# SALISBURY PARK NORTH PHASE 1

## TOWN OF PARKER SITE PLAN

NOVEMBER 22, 2024

**G-000**  
SITE PLAN SUBMITTAL  
Page 1 of 311

**C1-100**  
 SITE PLAN SUBMITTAL  
 Page 31 of 311

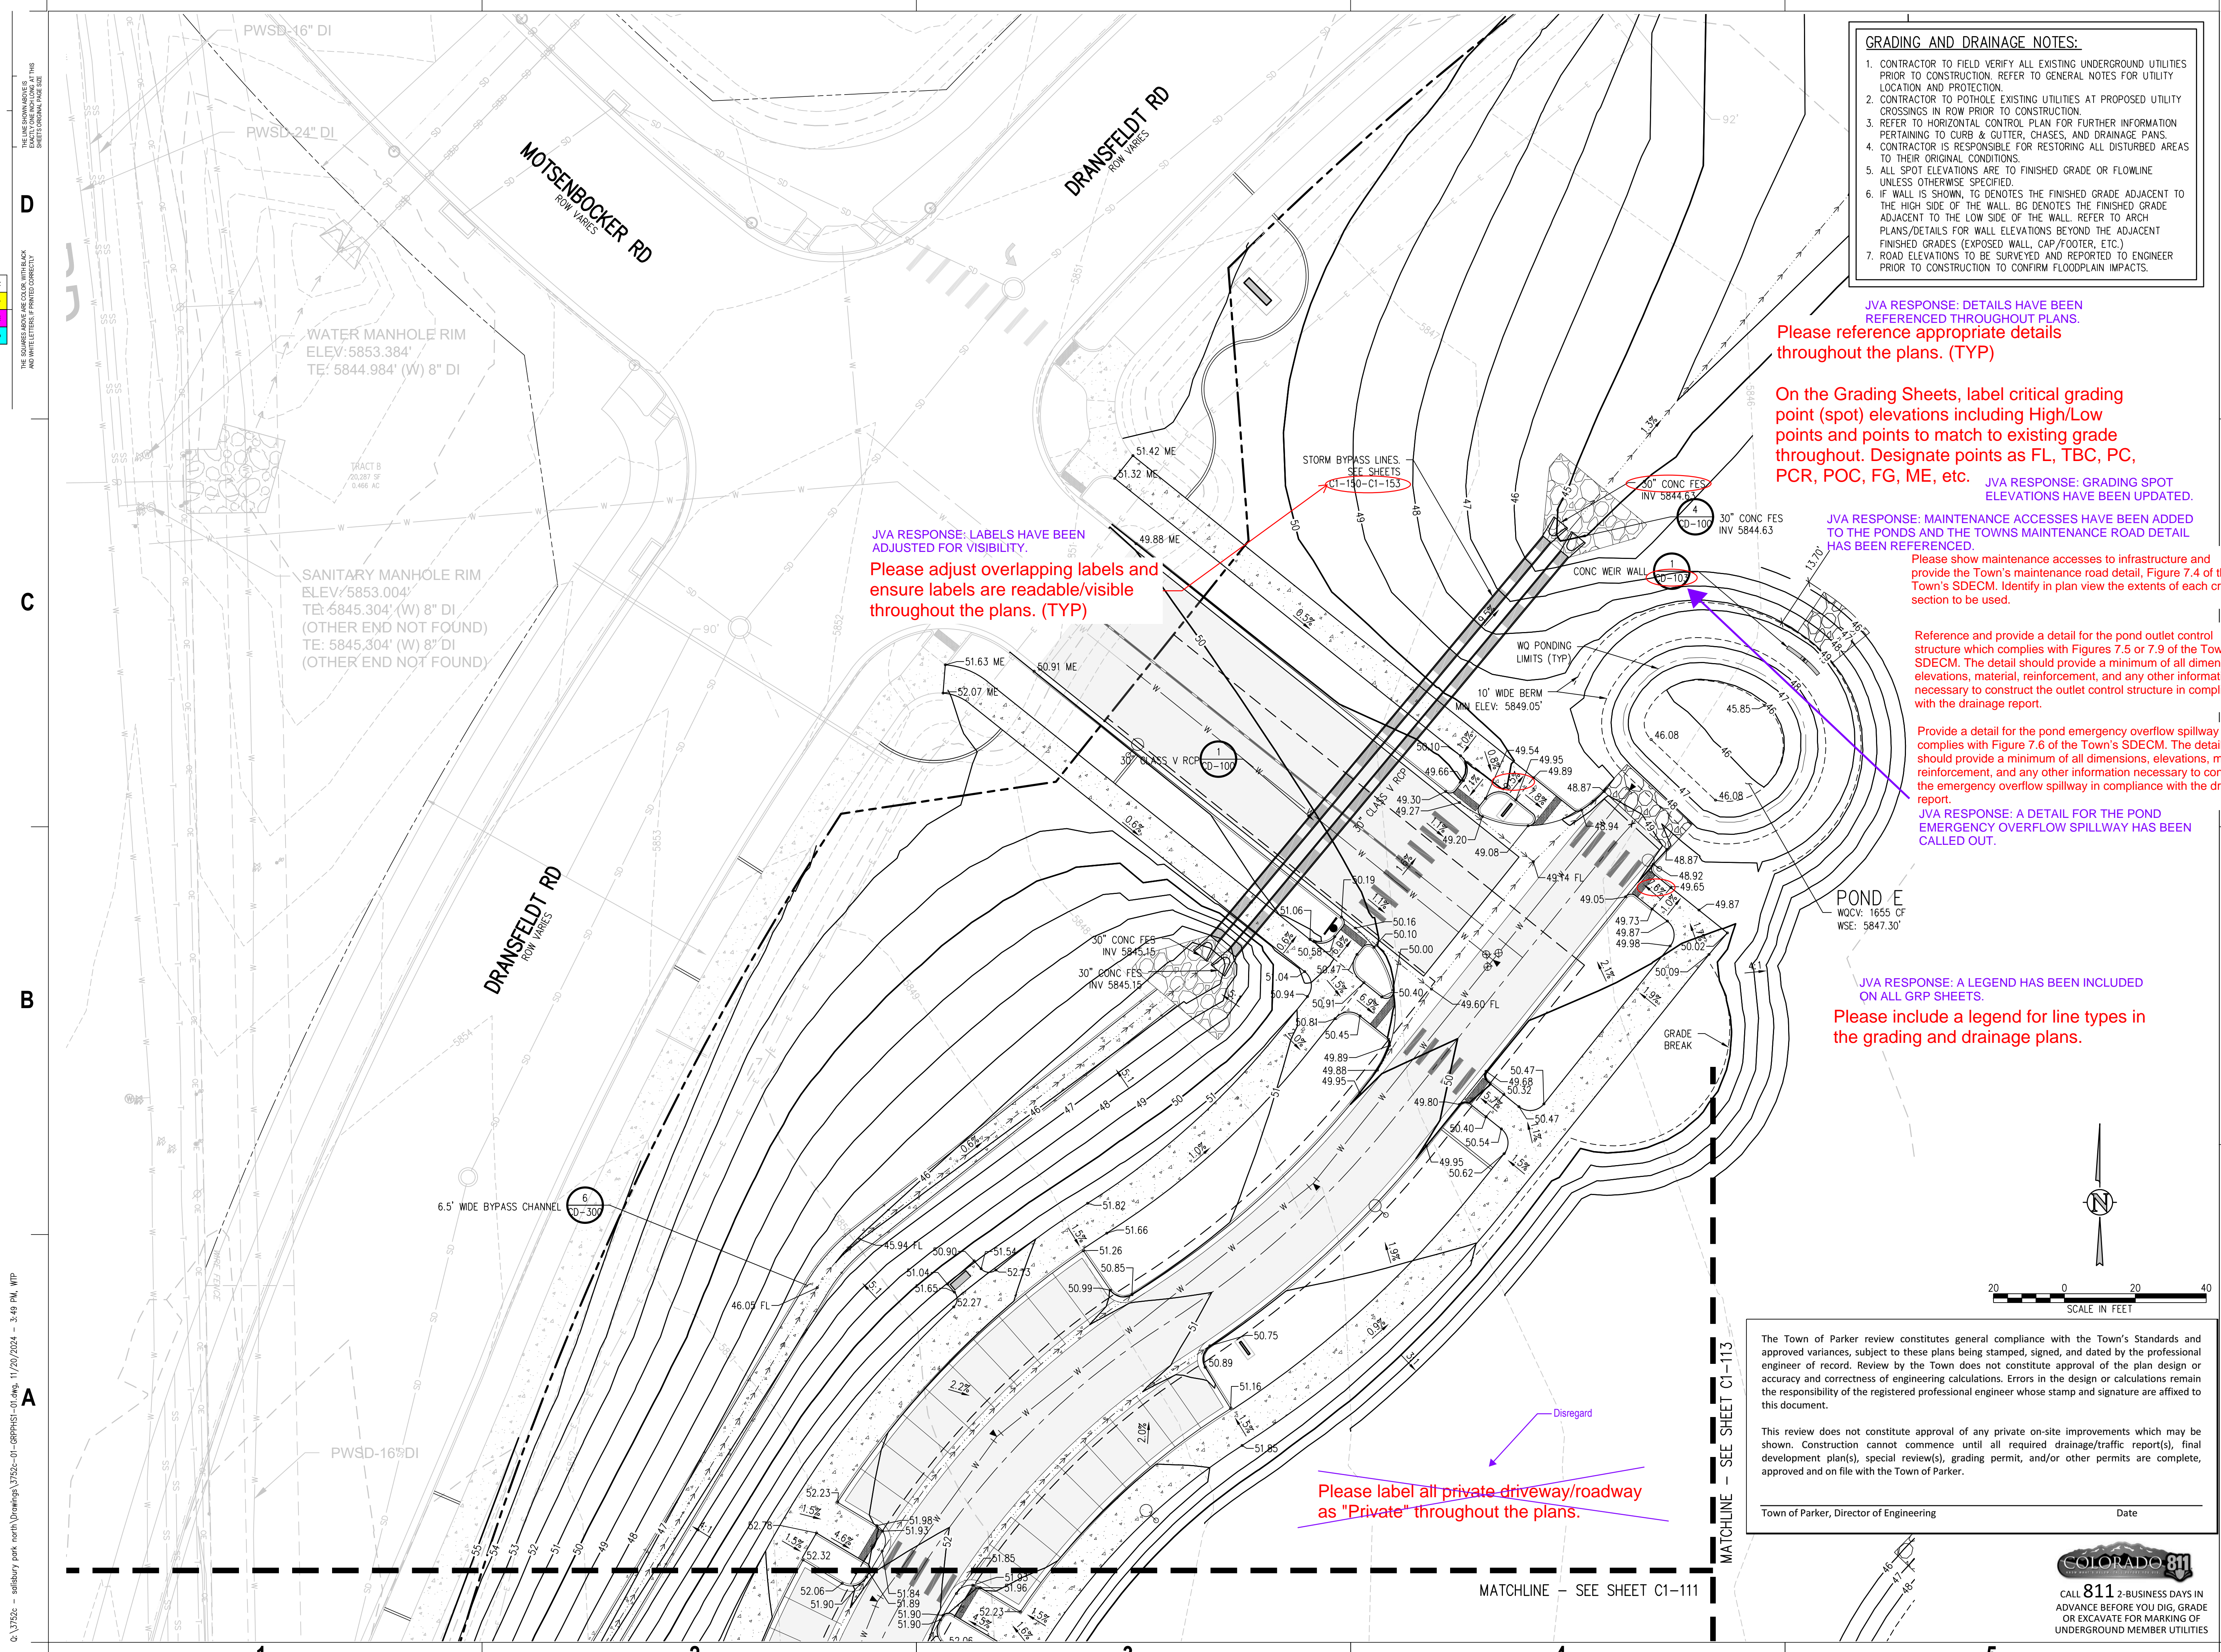
**JVA RESPONSE: MAINTENANCE ACCESSES HAVE BEEN ADDED TO THE PONDS AND THE TOWNS MAINTENANCE ROAD DETAIL HAS BEEN REFERENCED.**  
Please show maintenance accesses to infrastructure and provide the Town's maintenance road detail, Figure 7.4 of the Town's SDECM. Identify in plan view the extents of each cross section to be used.

**Reference and provide a detail for the pond outlet control structure which complies with Figures 7.5 or 7.9 of the Town's SDECM. The detail should provide a minimum of all dimensions, elevations, material, reinforcement, and any other information necessary to construct the outlet control structure in compliance with the drainage report.**

**Provide a detail for the pond emergency overflow spillway which complies with Figure 7.6 of the Town's SDECM. The detail should provide a minimum of all dimensions, elevations, material, reinforcement, and any other information necessary to construct the emergency overflow spillway in compliance with the drainage report.**  
JVA RESPONSE: A DETAIL FOR THE POND EMERGENCY OVERFLOW SPILLWAY HAS BEEN CALLED OUT.

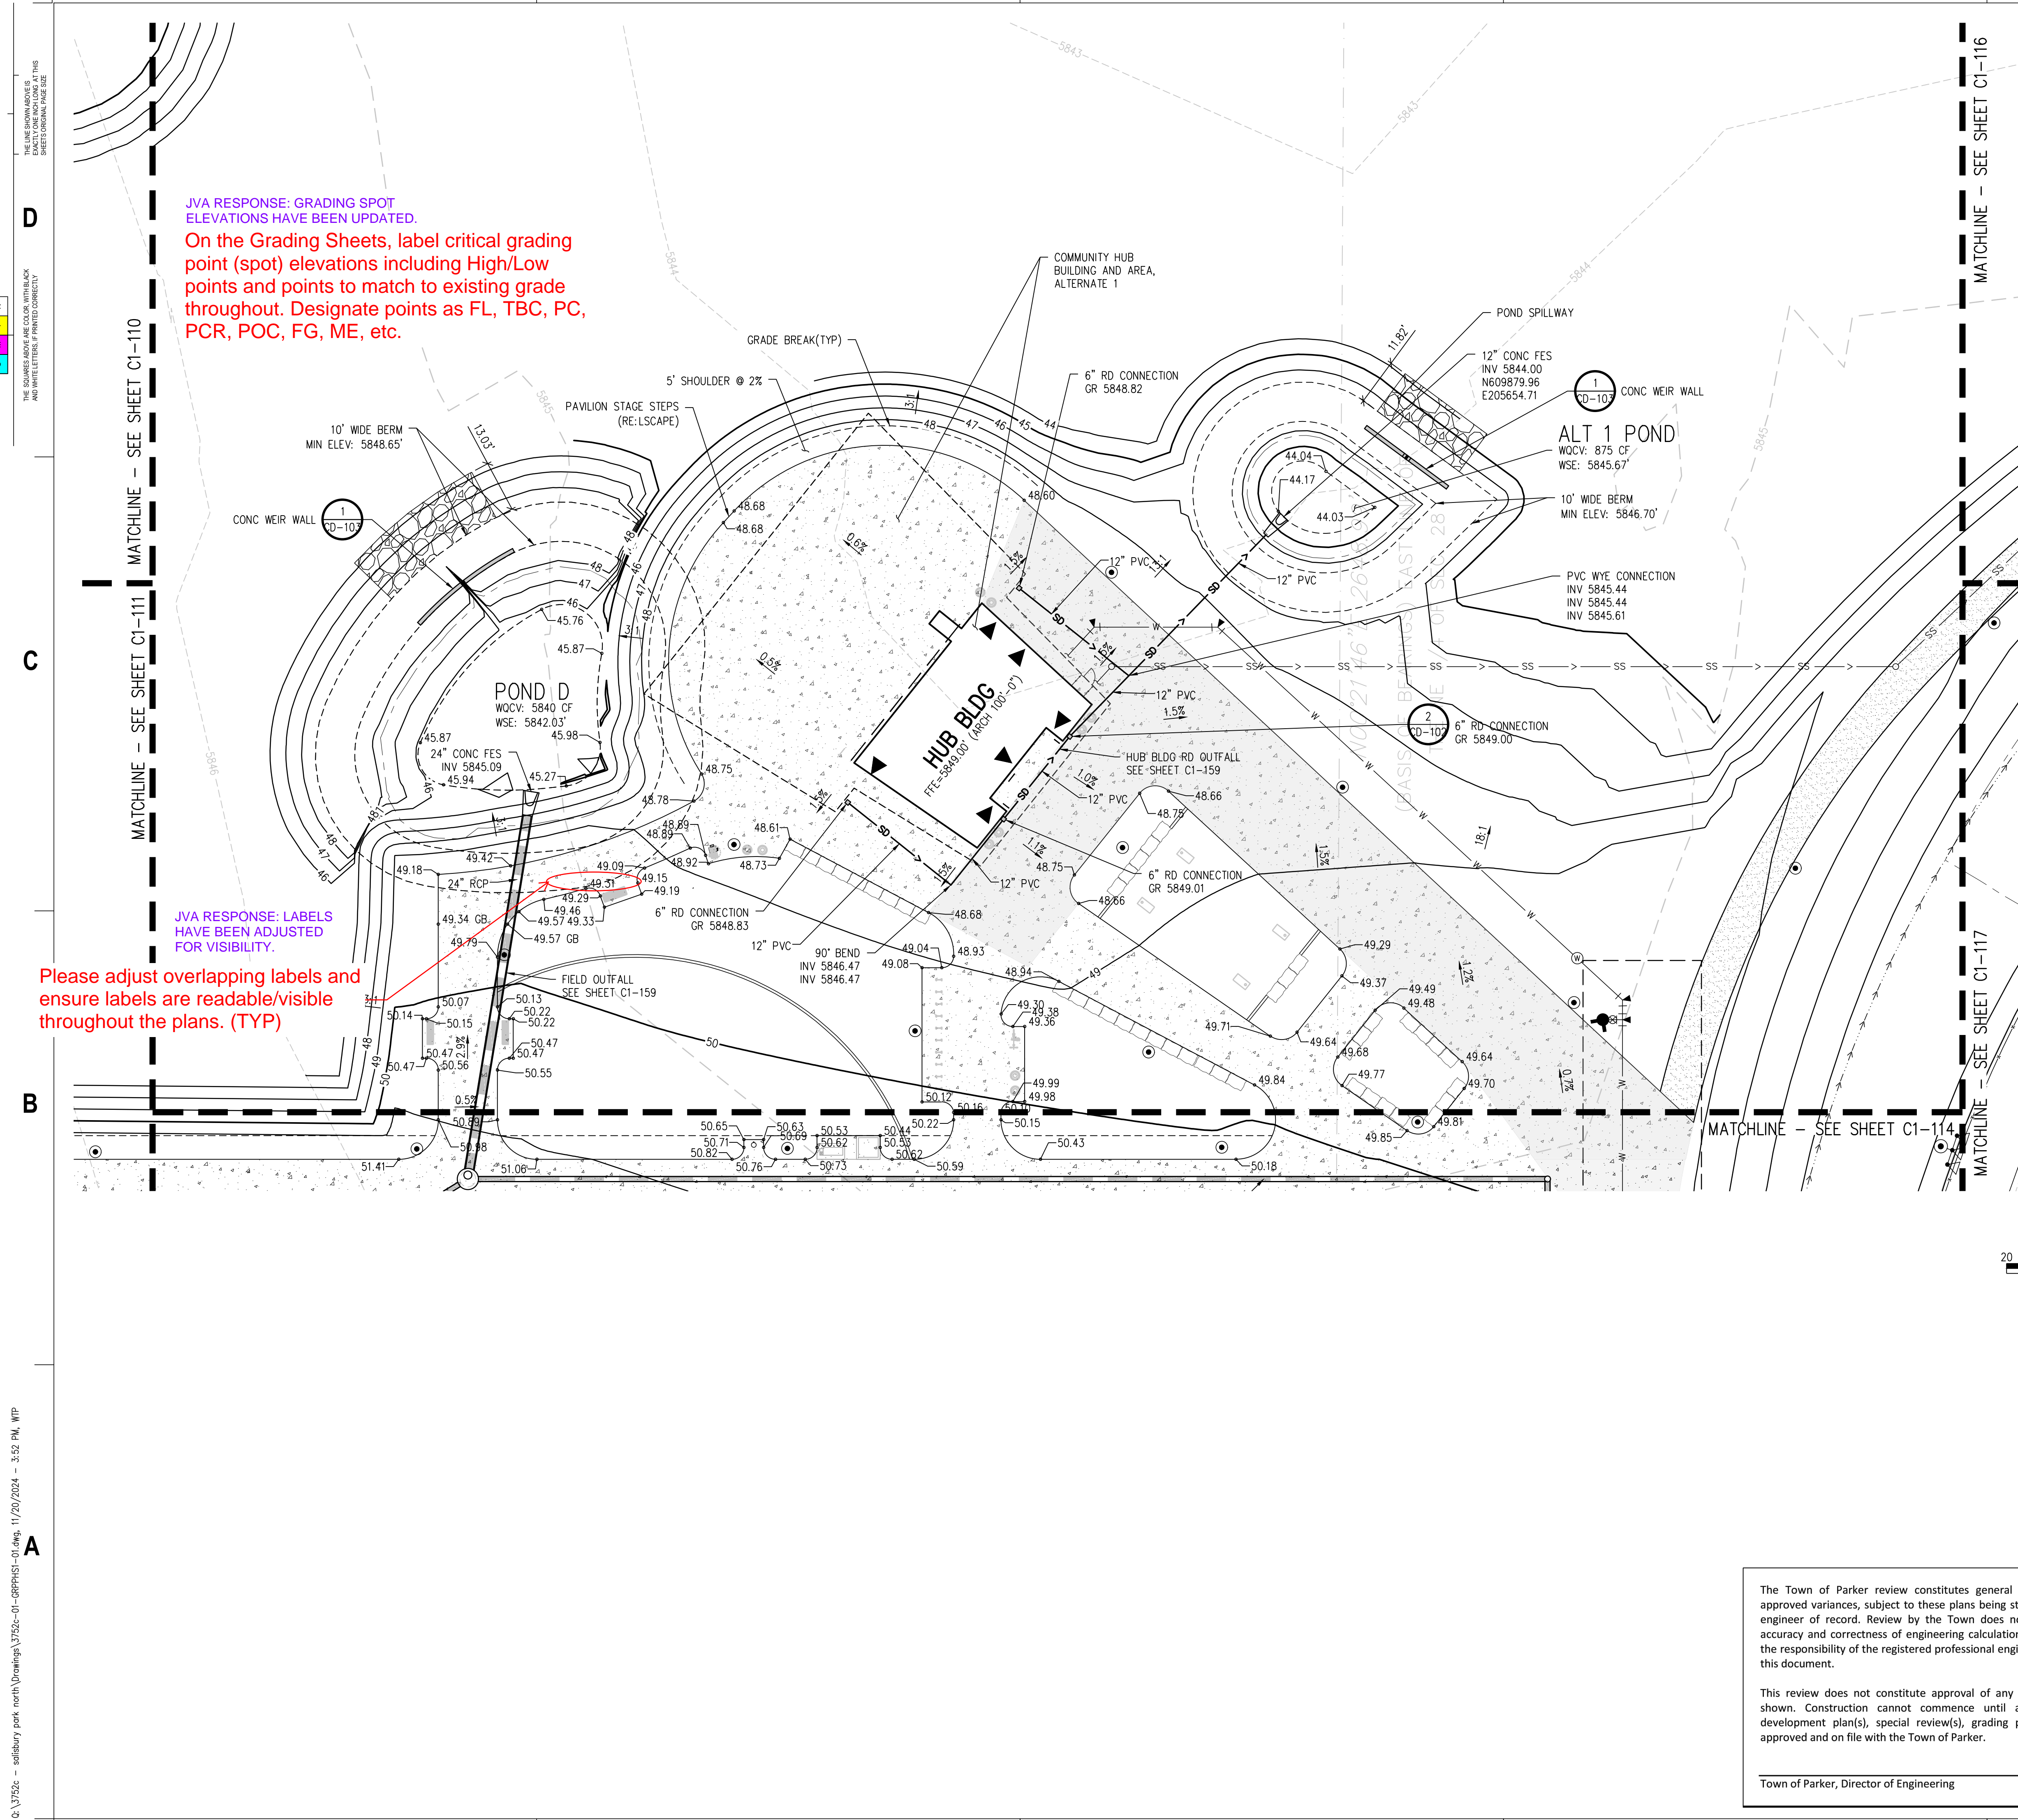
Provide a forebay and a detail for the pond forebay which complies with Figures 7.1 or 7.2 of the Town's SDEC. The detail should provide a minimum all dimensions, elevations, material, reinforcement, and any other information necessary to construct the forebay in compliance with the drainage report.

Provide a trickle channel and a detail for the pond trickle channel which complies with Figure 7.3 of the Town's SDEC. The detail should provide a minimum of all dimensions, elevations, material, reinforcement, and any other information necessary to construct the trickle channel in compliance with the drainage report.

Reference and provide a detail for the pond outlet control structure which complies with Figures 7.5 or 7.9 of the Town's SDEC. The detail should provide a minimum of all dimensions, elevations, material, reinforcement, and any other information necessary to construct the outlet control structure in compliance with the drainage report.

Please show maintenance accesses to infrastructure and provide the Town's maintenance road detail, Figure 7.4 of the Town's SDEC. Identify in plan view the extents of each cross section to be used.

Provide a detail for the pond emergency overflow spillway which complies with Figure 7.6 of the Town's SDEC. The detail should provide a minimum of all dimensions, elevations, material, reinforcement, and any other information necessary to construct the emergency overflow spillway in compliance with the drainage report.

JVA RESPONSE: MAINTENANCE ACCESSES HAVE BEEN ADDED TO THE PONDS AND THE TOWNS MAINTENANCE ROAD DETAIL HAS BEEN REFERENCED.
